Service Bulletin

Bulletin No.: 21-NA-074

Subject: Malfunction Indicator Lamp Illuminated On Driver Information Center (DIC) with DTC P0300 and/or P0299/P2227 Set

Brand:	Model:	Model Year:		VIN:		Engine:	Transmission:
		from	to	from	to		
Buick	Envision	2016	2020	-	-	Equipped with 2.0L Engine (RPO LTG)	All

5779438

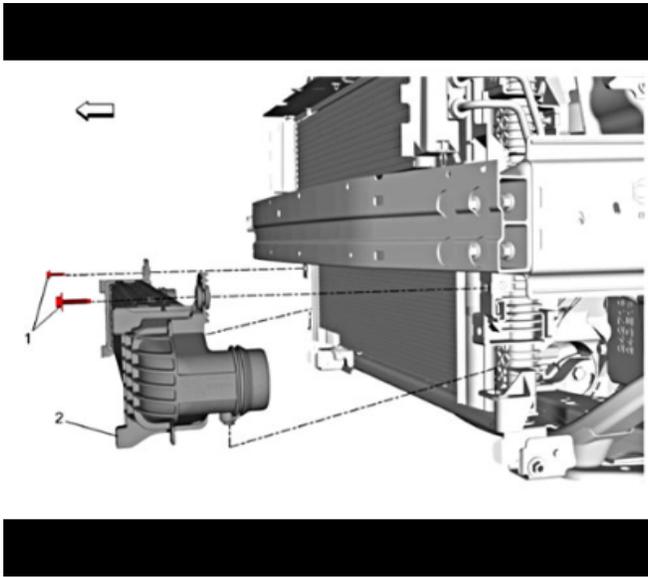
Important: The latest designed charge air cooler is wider, as shown in the picture above, and is NOT compatible with the existing lower baffle on vehicles built BEFORE January 5, 2019. The baffle will need to be replaced to accommodate the larger charge air cooler if the charge air cooler is being replaced
